# CITY OF SUNNYVALE REPORT ZONING ADMINISTRATOR HEARING

**File Number:** 2013-7540

**Location:** 733 S. Wolfe Rd. (near Old San Francisco Rd.) (211-05-032)

**Project Description:** Use permit to allow a recreational and athletic facility in a tenant space formerly utilized as a grocery store.

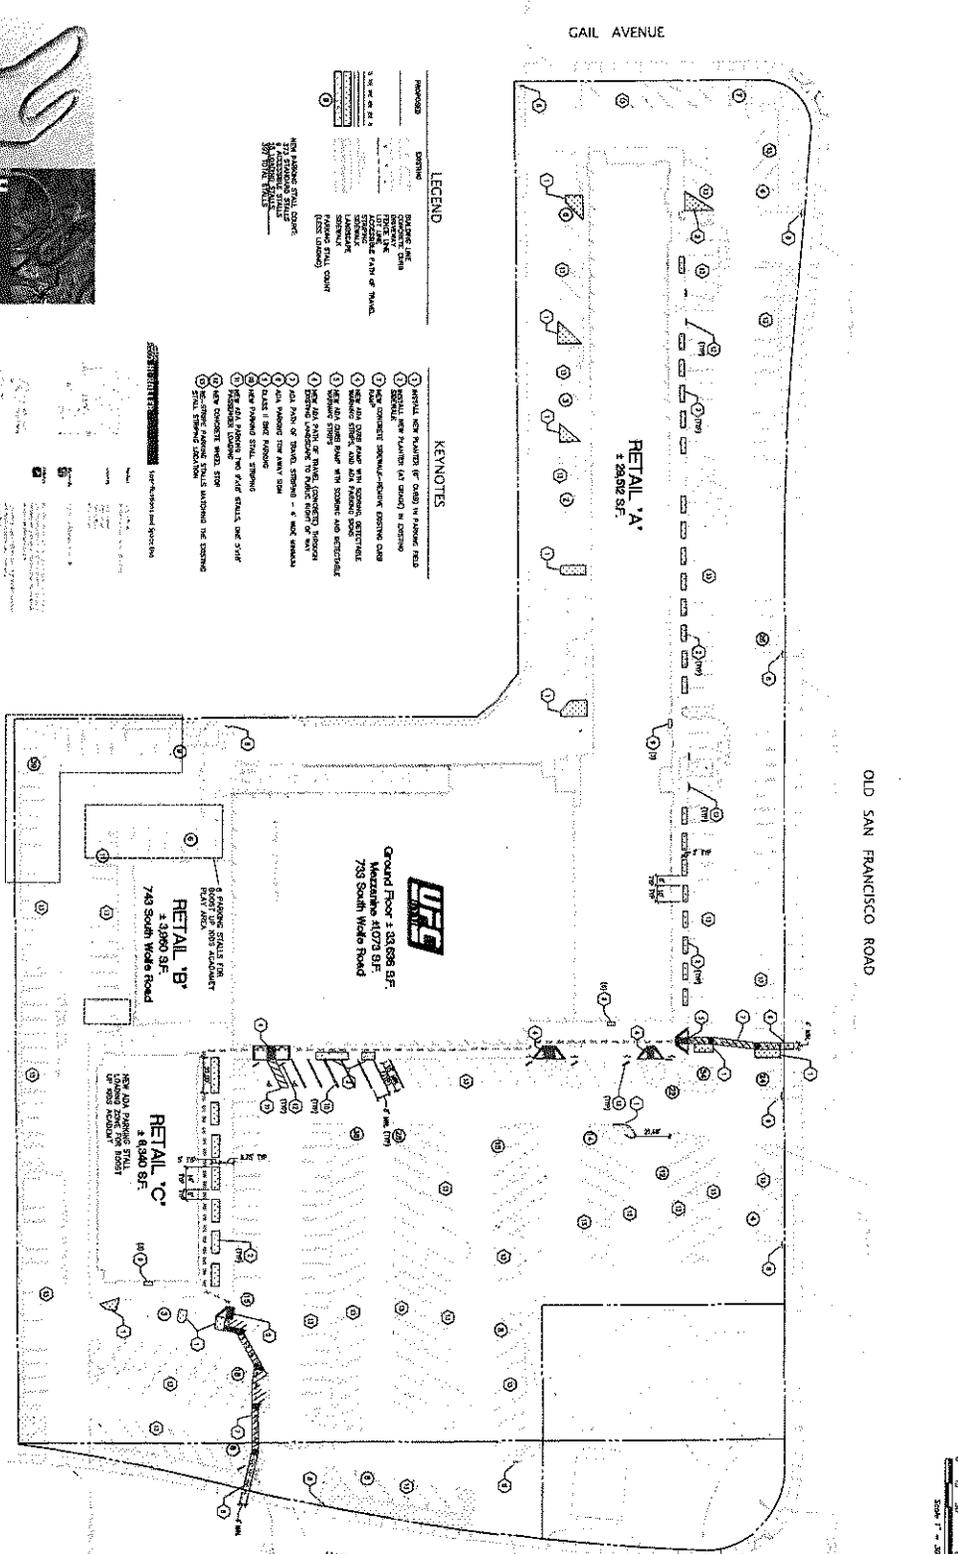
Current City Code requires a minimum of 20 percent nonresidential parking lot area be landscaped, with 50 percent parking area shaded at vegetative maturity. Submitted plans indicate roughly 16.6% of parking lot landscaping proposed. As of the writing of this report, data regarding landscape shading was not yet available.

Additional landscaping is necessary in order to meet City of Sunnyvale Municipal Code requirements for minimum landscaped area and parking lot shading. However, parking capacity also remains deficient per Code, and substitution of parking with landscaping is not advised. Staff recommends that additional landscaping be placed in existing planter boxes throughout the paved parking area and its periphery, and that new planter boxes and tree wells be installed in available locations. To the extent possible, staff recommends limiting physical alteration to the parking lot area as a means of avoiding disruption of tenant operations. Staff notes that, to some degree, the physical layout of the center constrains areas available for added landscaping. The presence of overhead utility lines and underground sanitary sewer on the easterly side of the lot, which run roughly parallel to S. Wolfe Rd., further restrict the available size and placement of landscaping. Nevertheless, the current deficiency in landscaping must be rectified to the extent practicable.

- a) The paths of access for handicapped accessibility shall coincide with those included in plans approved for the Use Permit issued for the marital arts school (childcare center) at 743 S. Wolfe Rd. (Planning Permit 2012-7413).
- b) Additional landscaping shall be installed throughout the site to fulfill minimum Municipal Code requirements that 20 percent of the parking lot area be landscaped, and 50 of the parking lot be shaded at vegetative maturity, to the extent possible. The final landscaping plan is subject to review and approval by the Director of Community Development.
- c) Consider adding a washer and dryer to the proposed floor plan to provide for laundering of gym towels, clothing, and the like.
- d) No further development shall take place within public utility easements. [COA] [PLANNING]:

Specify restriping of existing parking spaces on the Building Permit plans. The parking spaces located directly adjacent to the entry façade (easterly side) of the subject tenant space (approximately 19 spaces) shall be restriped in accordance with Title 19 of the Sunnyvale Municipal Code. Such restriping shall coincide with that included in plans approved for the Use Permit issued for the marital arts school (childcare center) at 743 S. Wolfe Rd. (Planning Permit 2012-7413). [COA] [PLANNING]

PRELIMINARY ROOF PLAN

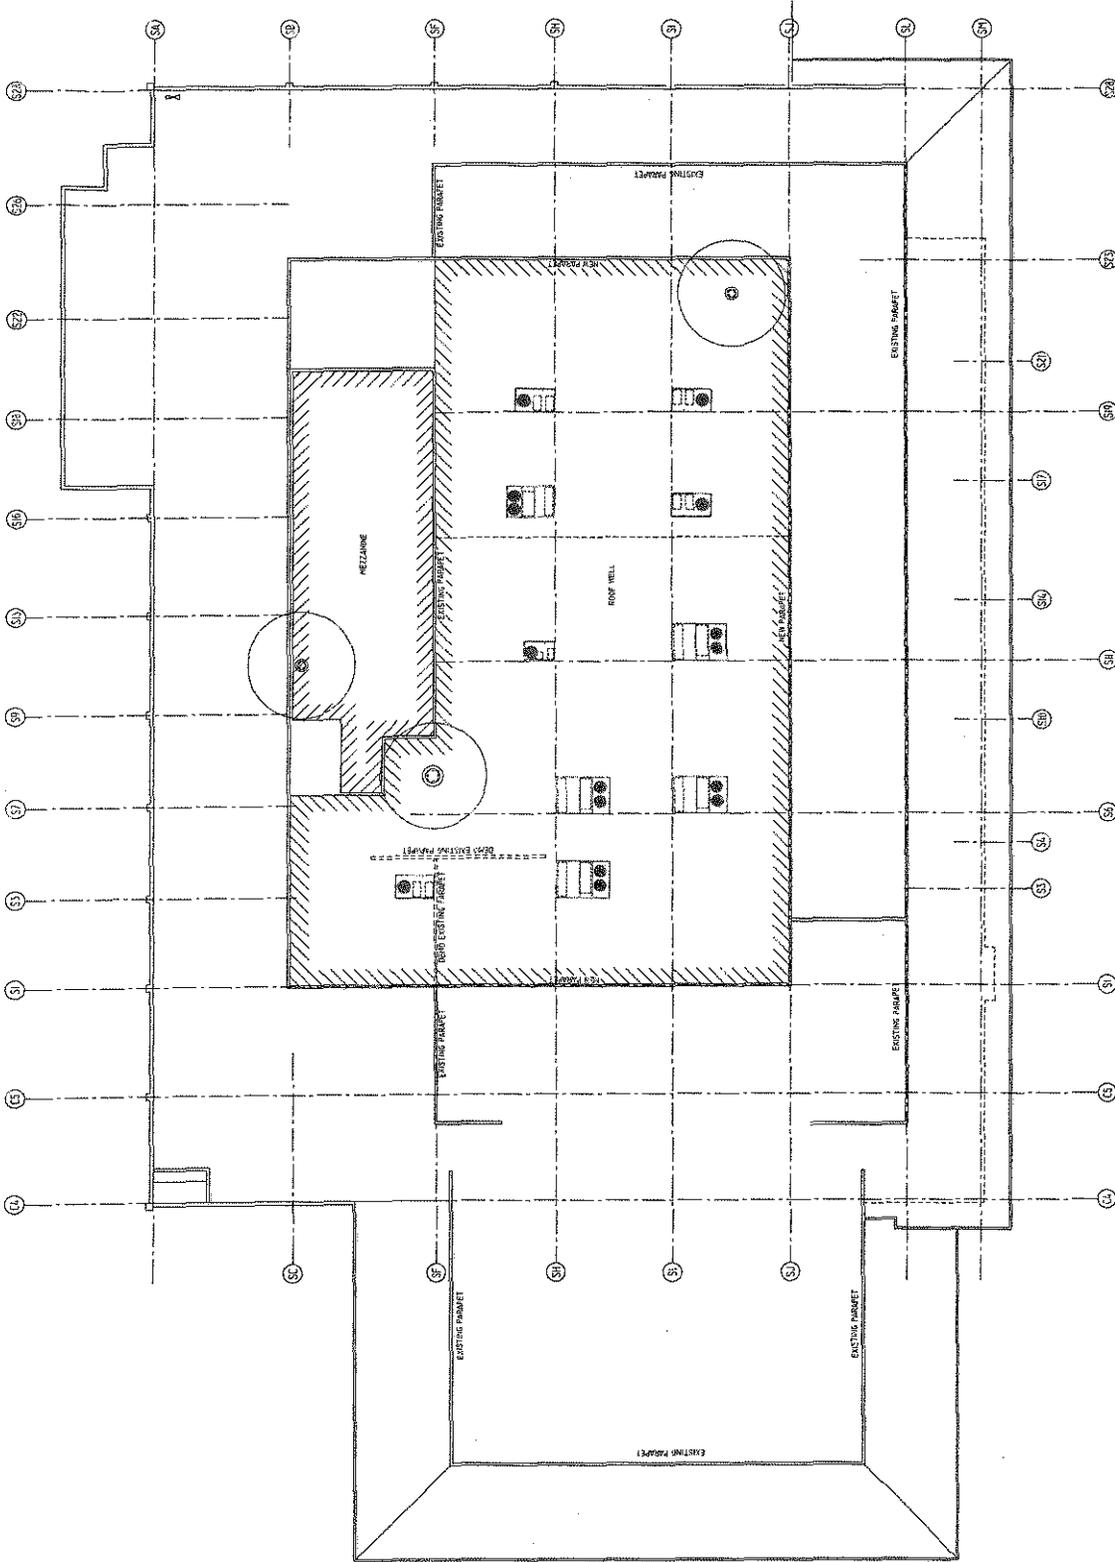
- 1. THE HEIGHT OF THE ROOF SCREEN MUST BE MINIMALLY AS HIGH AS THE HIGHEST POINT OF ROOFTOP MECHANICAL EQUIPMENT TO BE SCREENED.
- 2. ALL ROOFTOP EQUIPMENT WILL BE REPLACED WITH NEW EQUIPMENT.
